**From:** Mess, Camie  
**Sent:** Tuesday, August 15, 2017 2:59 PM  
**To:** reoutlaw@earthlink.net  
**Subject:** BAR Action - 430 North 1st Street - Aug. 14th, 2017

BAR 17-08-03  
430 North 1<sup>st</sup> Street  
Tax Parcel 330088100  
David and Nancy Hughes, Owner/ Outlaw Design Company, Applicant  
Street Additions

**CITY OF CHARLOTTESVILLE  
BOARD OF ARCHITECTURAL REVIEW  
STAFF REPORT  
August 14, 2017**

BAR 17-08-03

perspective looking southeast of proposed entry deck - 430 N. 1st St.

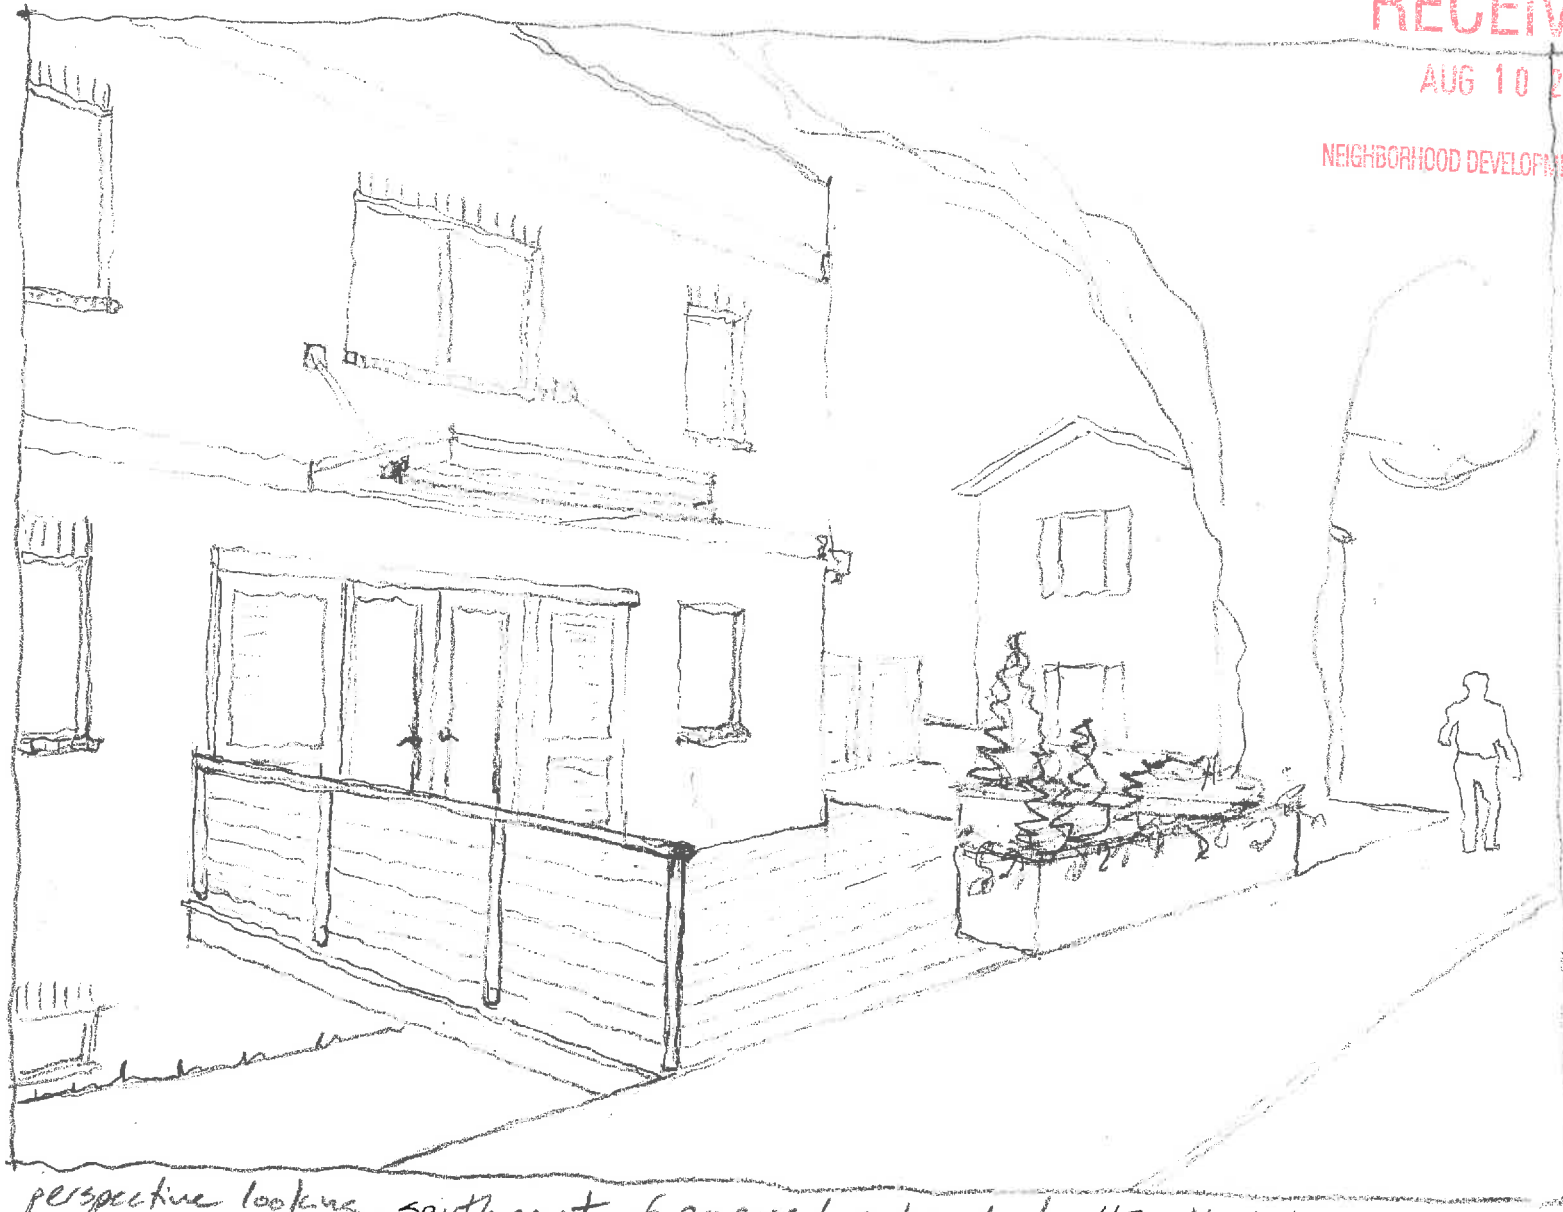
**The large part of the discussion was centered around the front entrance bridge and the symmetry of the house. The members present felt this is the most character defining feature of the structure, and were hesitant to see it changed. It was suggested if the applicants wanted a front occupiable space, that they sink it down or make it symmetrical. Another suggestion was to make the cantilevered canopy reinforcements less noticeable keeping with the original designs intention. The BAR thought the side and back additions were appropriate according to the guidelines.**

It is good to see new owners taking care of this special house that is in need of maintenance. Most of the proposed changes are appropriate per the Guidelines. Staff has identified the main issue being the dramatic change in configuration of the entry walkway, which the BAR should discuss.

○ EAST ELEVATION  
1/4" = 1'-0"

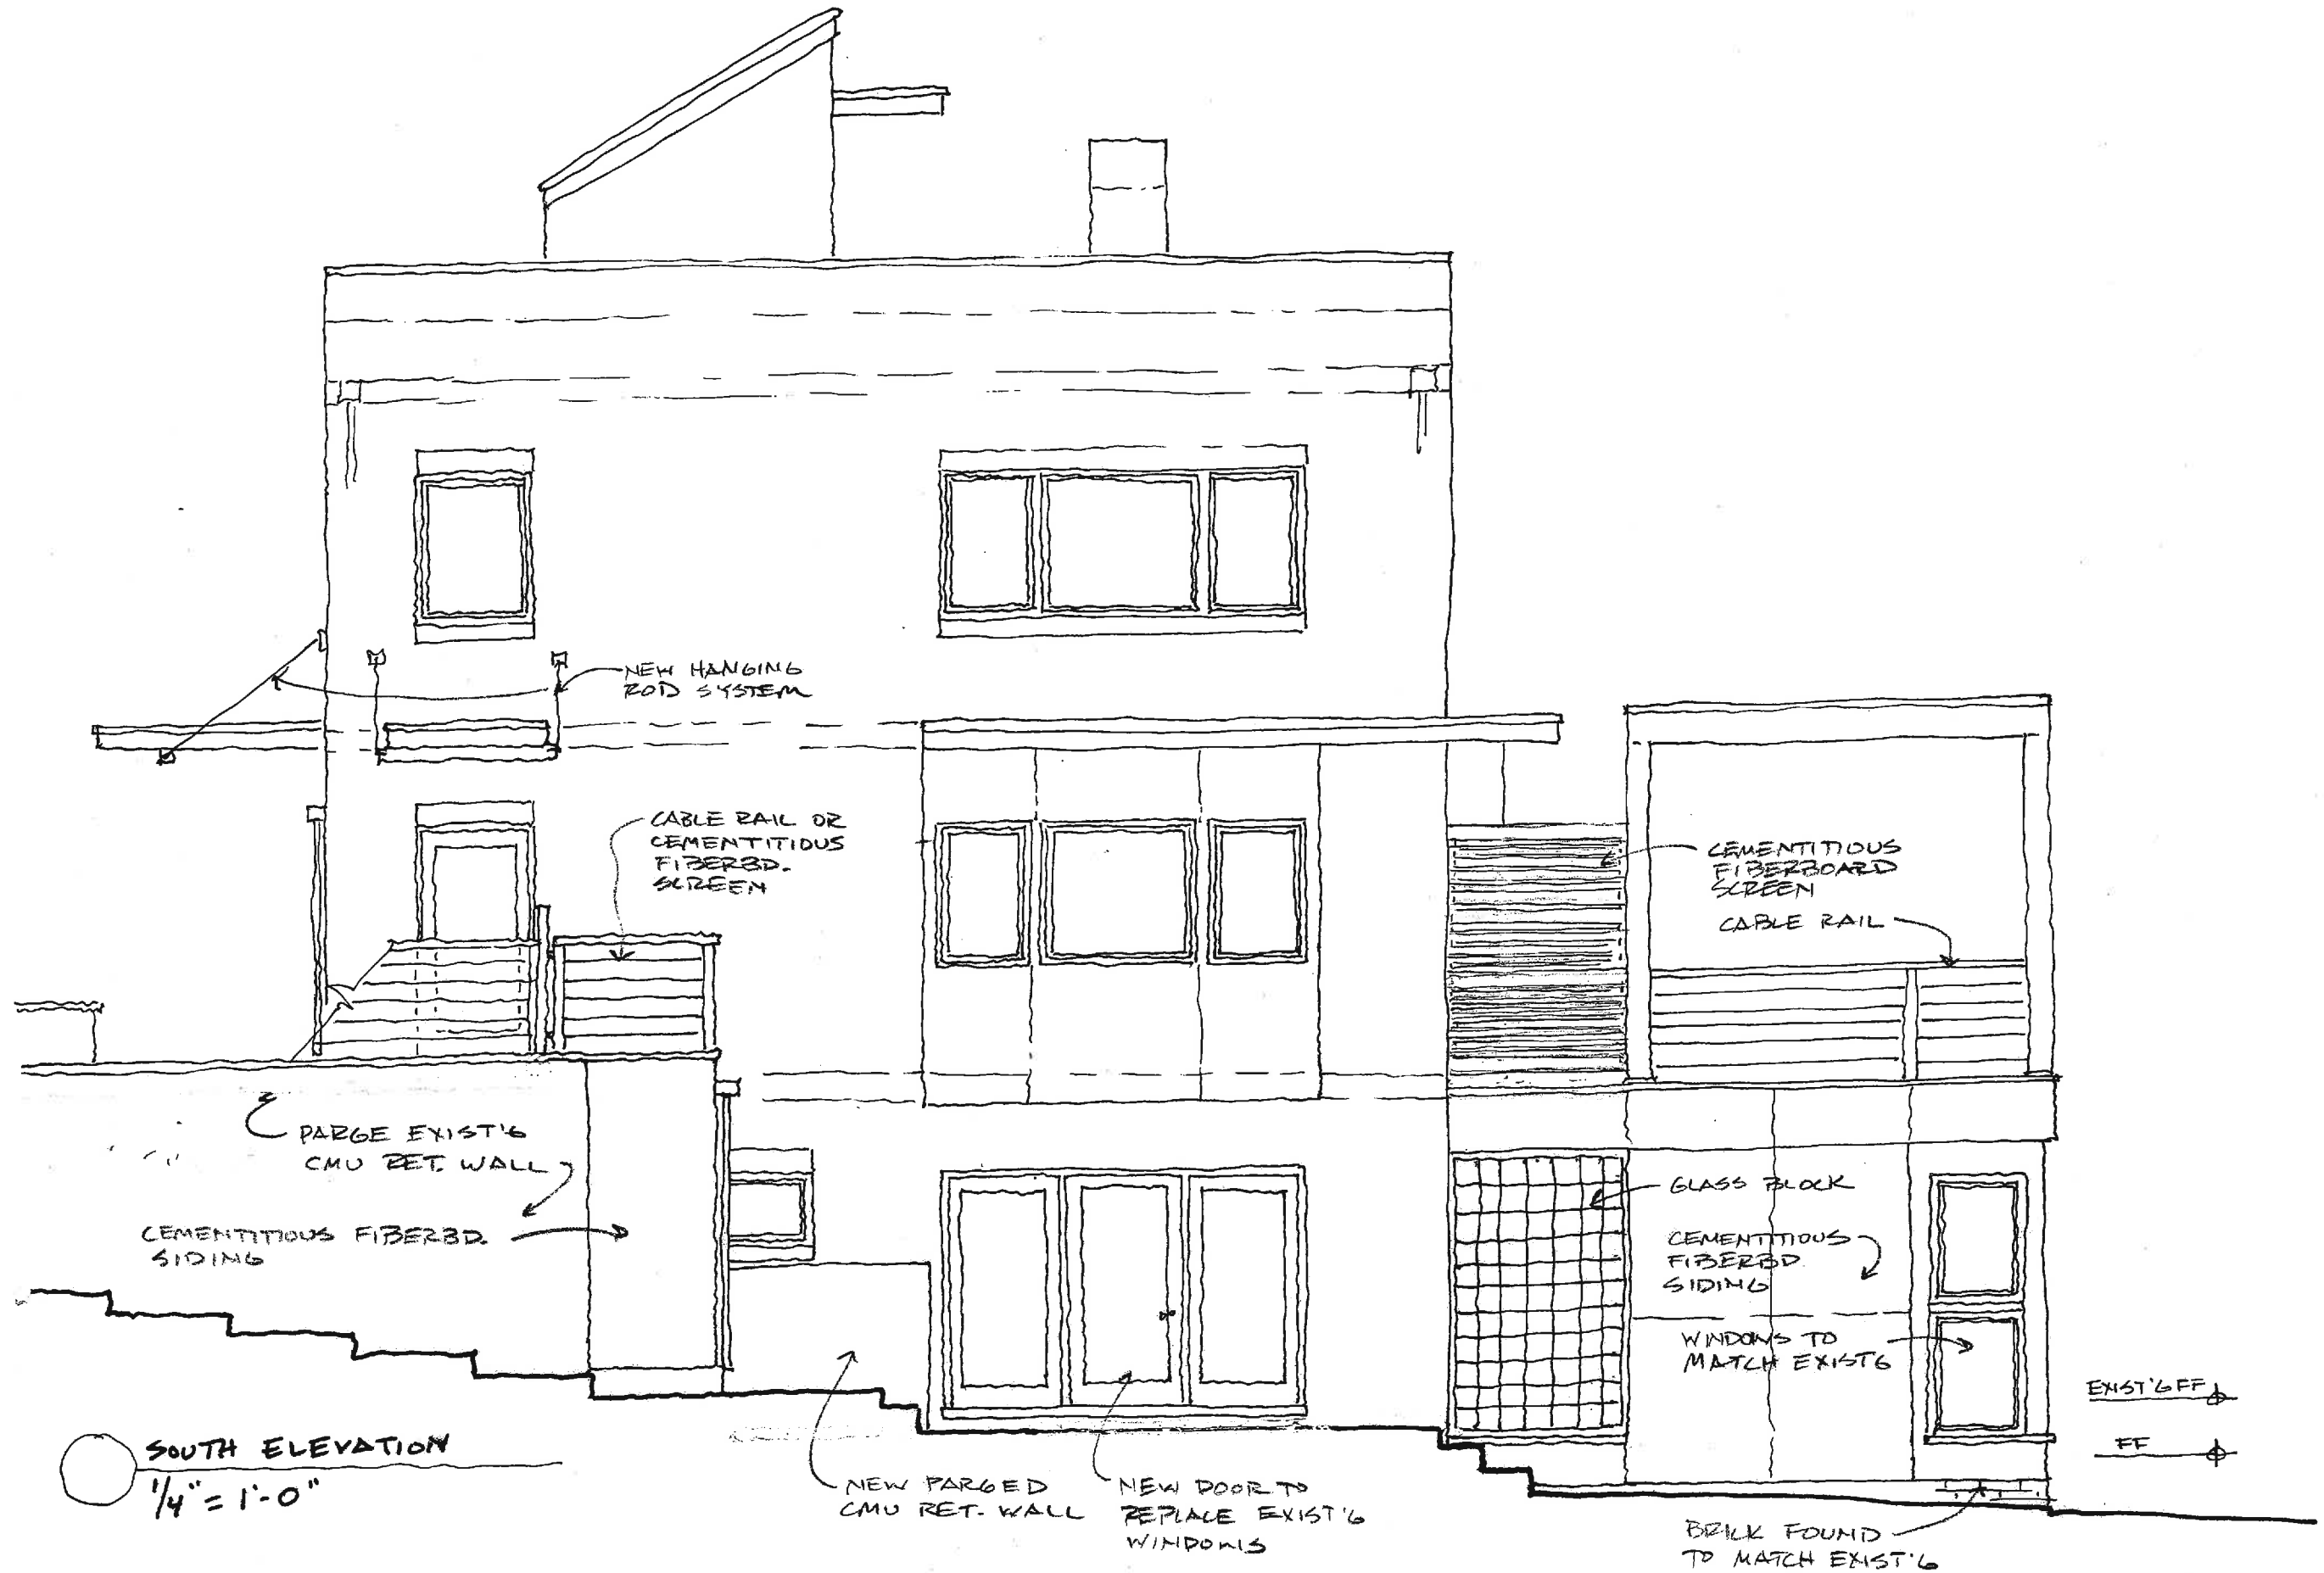
Prelim discussion; this is a locally-significant house, done by a UVA Arch Professor, Vickery. If the rear additions are not visible from street view, I am not that concerned with them, but I do think the approach from the street to the main entrance is significant. I totally get the desire to have more usable space in the front yard between the house and the sidewalk, but I would encourage a design that somehow maintains or pays homage to the axial walkway as the house looks today. residences must evolve, of course, but it might be possible to design in a reference to the current configuration. It's a great house!
